REQUEST FOR QUOTATION

TRANSNET FREIGHT RAIL - RME  
TFRRFQ BOARD-RME  
PROCUREMENT DEPARTMENT  
Aguilhas lighthouse

Transnet Capital Projects  
**RFQ Number / Date**  
6000166772 / 12.07.2013  
**Contact Person / Telephone**  
Yandiswa Oldjohn / 021 940 1886  
**Return to VAX Number/EMAIL**  
0218100000 / TCPtendersCapeTown@Transnet.net

Supply & manufacture  
316 stainless steel handrails to tower top  
install, refurbished baulsters.  
4 rails of 1 1/4"

1/6/13. SKETCH 3.  
Roumie Ghur Architects

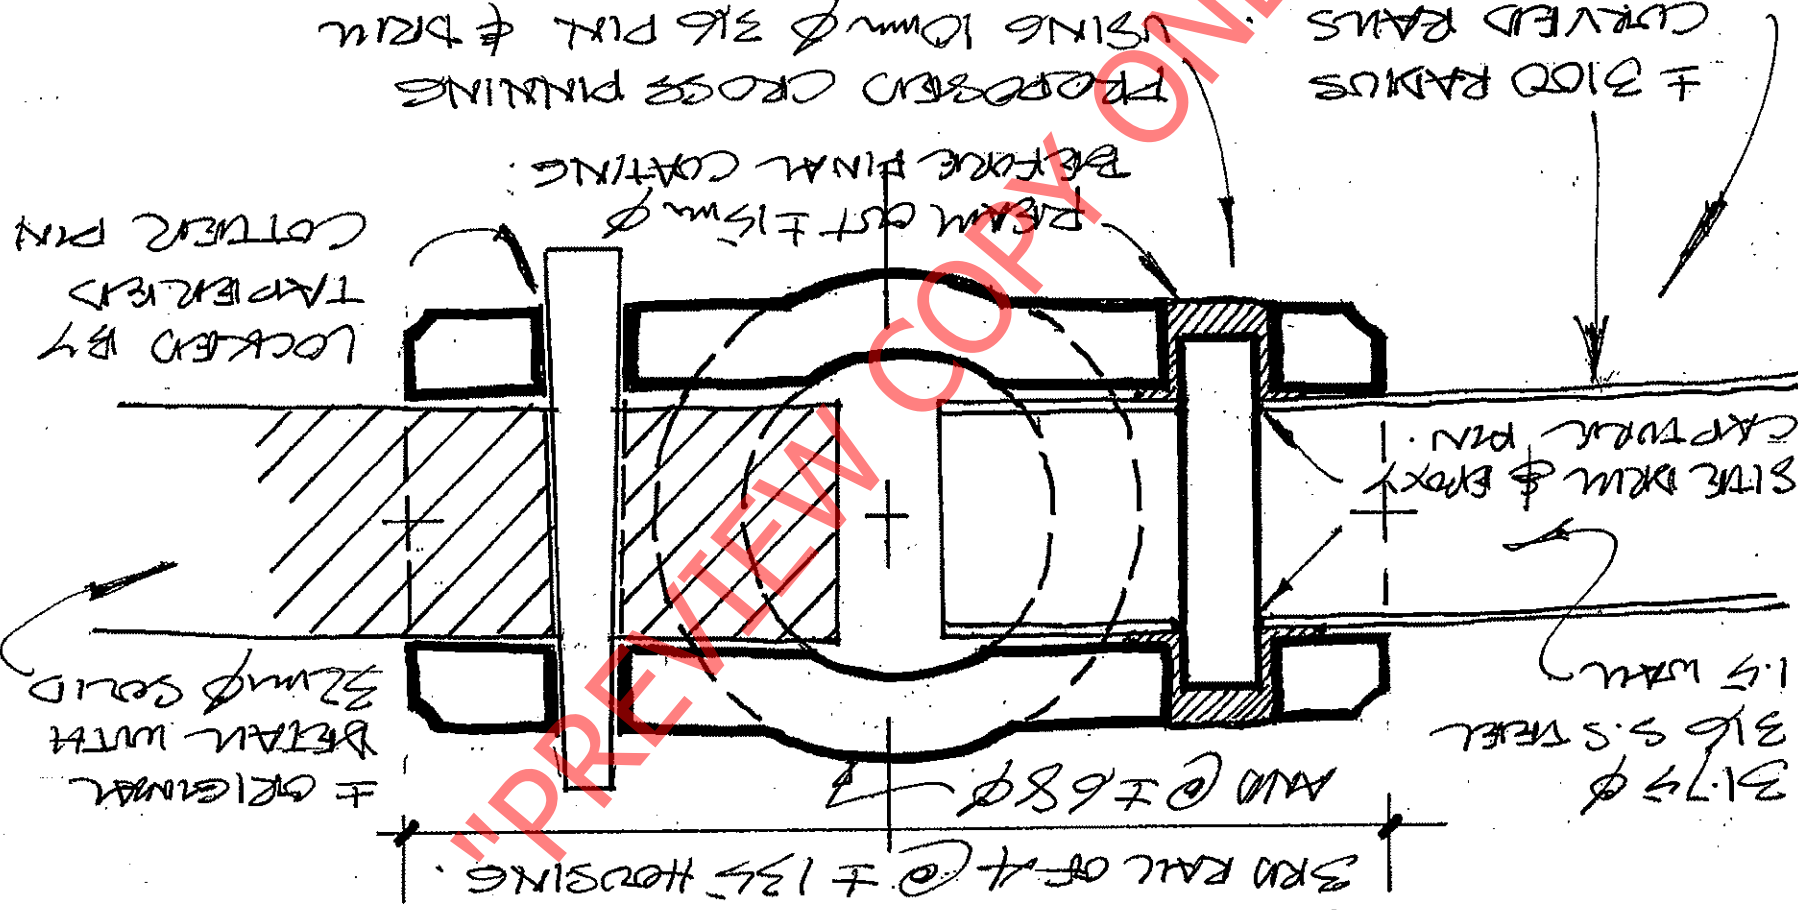
THE 1310 EDGE TO PERISTYLE TOP - MEASURED.  
 I GOT 2345 EDGE TO CENTERLINE OF BRUSTERS (BUT 1310 SHOWS SHOTS MAKE #270).  
 " " 230 PERISTYLE WALL + TOP AS SHOWN.  
 COULD YOU TRAP THE CIRCUMFERENCE AROUND THE PERISTYLE, AROUND THE PERISTYLE TOP AND AROUND THE CENTER EDGE? \*

SITE DRUM & EPOXY  
CAPTIVE PIN.

LOCKED BY  
TAPERED  
COTTER PIN

BEFORE FINAL COATING  
BEAM OUT ± 15mm

PROPOSED CROSS PILING

USING 10mm Ø 316 P/N & DRUM

TURN ON SITE & FLUSH

Remie Scour Adenduff SKETCH 6/8/13.

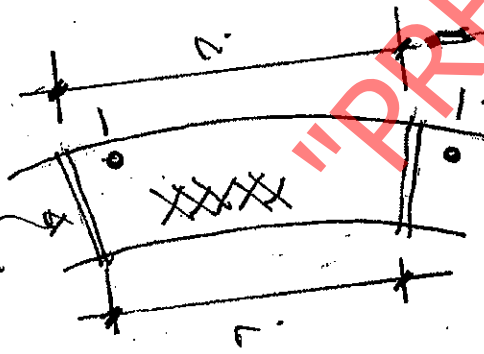
SKETCH/CHECK TYPICAL PANEL SIZE. 13 IDENTICAL?

SUGGESTED NEW MIDRAIL

SAY  $40 \times 8$ ?  
(ALSO ROUNDED TO CURVE)

?  $\pm 480-500$  TO GLASS - CHECK.

?  $\pm 420$  TO DRUM BELOW.

?  $75$ mm OFFSET

? TAPPED INTO C-IRON
